# Access Compliance Report

## Public Rights-of-Way

### (Pedestrian Signals)

| ADA ID: B6A21CB6137E                    | Signal Type: Two Push Buttons-APS | Overall Compliance: No                  | Severity Score: BTN 1:N/A BTN 2: N/A No BTN: N/A |

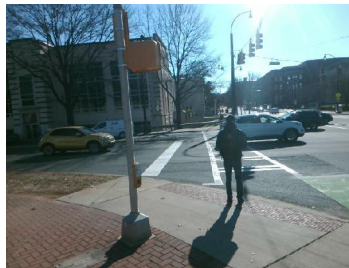
PROW/ADA: TMUTCD 4e.08, R404.2, R406.2,

| Compliance | Description                             | Data    | Compliance | Description                            | Data |
|------------|-----------------------------------------|---------|------------|----------------------------------------|------|
| No         | B 1 Clear Floor Space XSlope (%)        | 5.6     | No         | B 2 Clear Floor Space XSlope (%)       | 4.7  |

| Yes | B 1 DistanceTo XWalk (in) | 0.0           | No  | B 2 DistanceTo XWalk (in) | 64.0          |
| No  | B 1 DistanceTo Curb (in)  | 135.0         | No  | B 2 DistanceTo Curb (in)  | 120.0         |

Possible Solutions: Replace Signal Push Button With APS Button on New Post. Remove & Relocate Sign.
